Paradox Security Systems Ltd
780 Industriel Blvd, Saint-Eustache, Quebec J7R 5V3, Canada

FCC ID Certification No.: KDYK70M

Original product name: 7 inch Touchscreen Keypad

We, the undersigned, hereby attest to the fact that we will apply the class II change. The hardware of this equipment is electrically identical with original, only the follow changes to the original but still compliance of relevant standard.

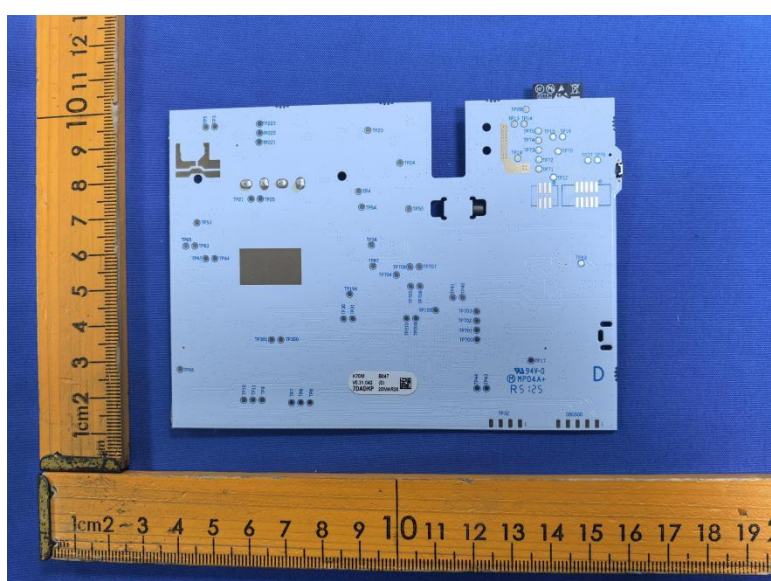
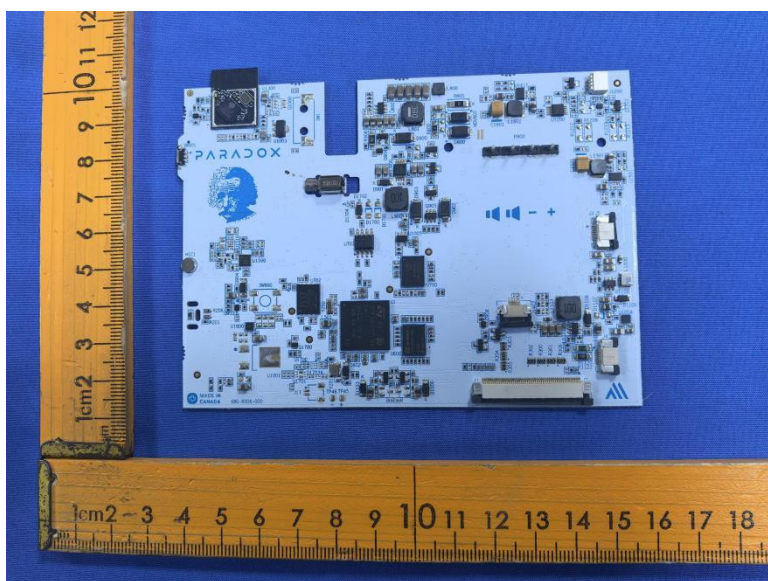
Mainly it relates to change of memories. There is nothing to affect the WiFi transmission or radiation.
EMMC/SD removed and use SPI flash instead.

Replace I2C EEPROM by SPI EEPROM for higher size (1Mbyte).

Added main power 5V reset.

Added capability to power on from battery.

Added 24MHz HSE crystal.

Charger NTC correction.
